February 3, 2023

**Rainforth Grau Architects Project No.22-1515**  
DSA File and Application No. 39-73 / 02-120733  
PTN: 75499-180

## ADDENDUM NO. 1

Villalovoz Elementary School, Inc. #2  
Tracy, California

## 9 PARAPET AT MANSARD

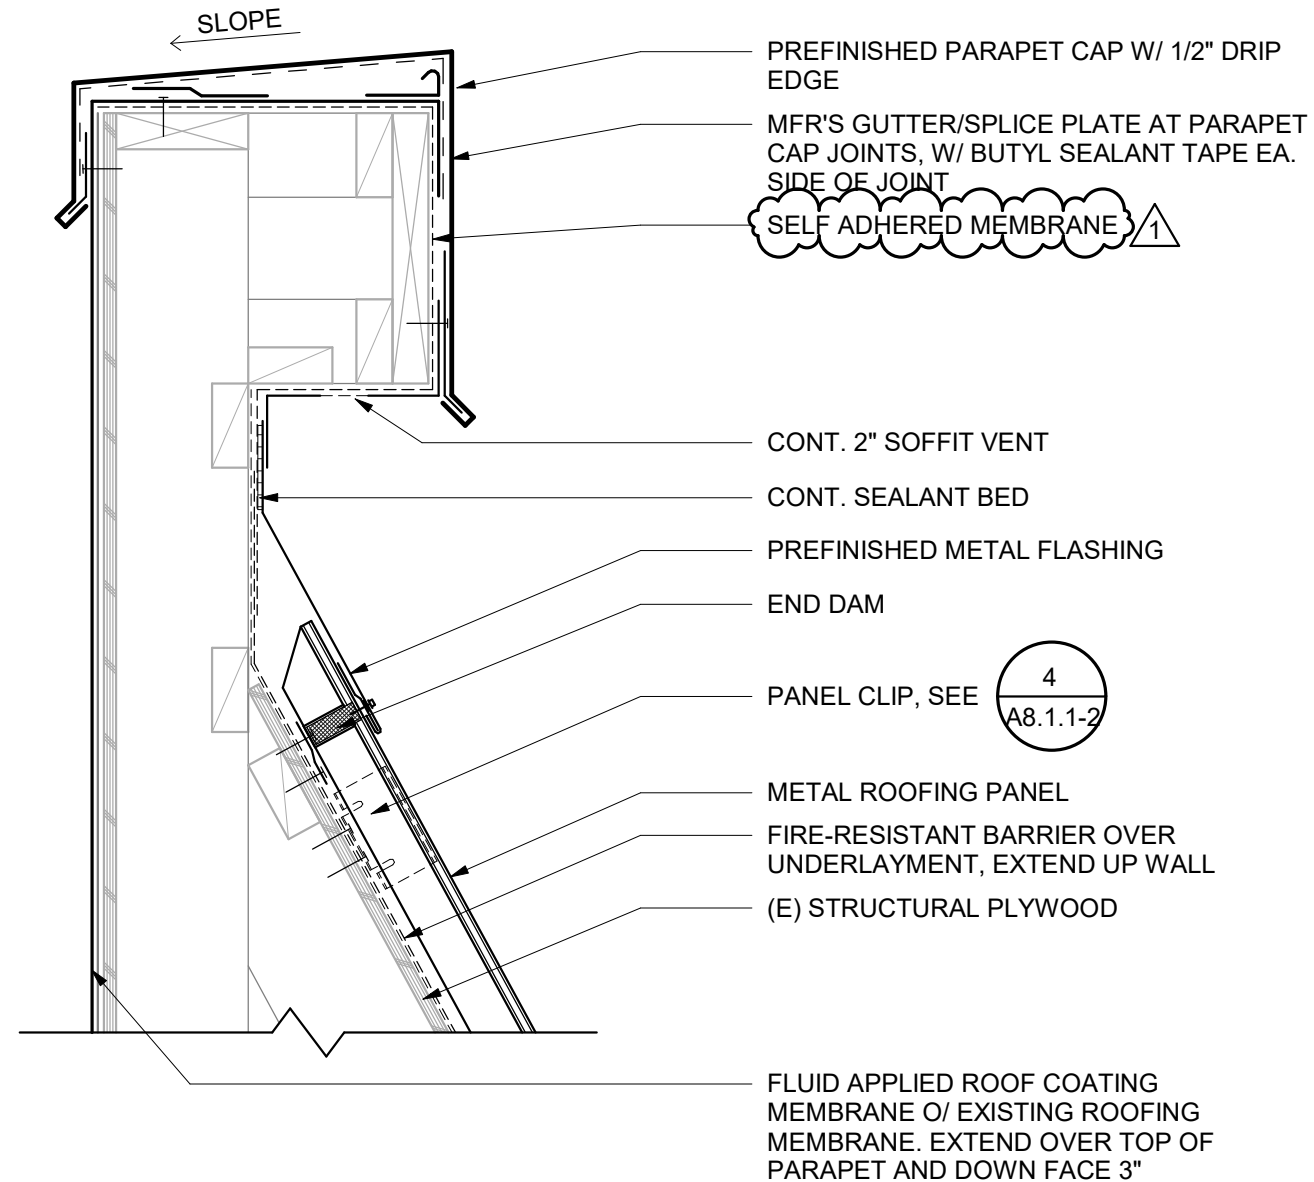
1. REVISE detail 9, PARAPET AT MANSARD per sheet AD1.12 included with this addendum
- M. Sheet E0.0.1-2, SHEET INDEX AND SYMBOLS
1. DELETE sheet in its entirety and REPLACE with sheet AD1.13 included with this addendum.
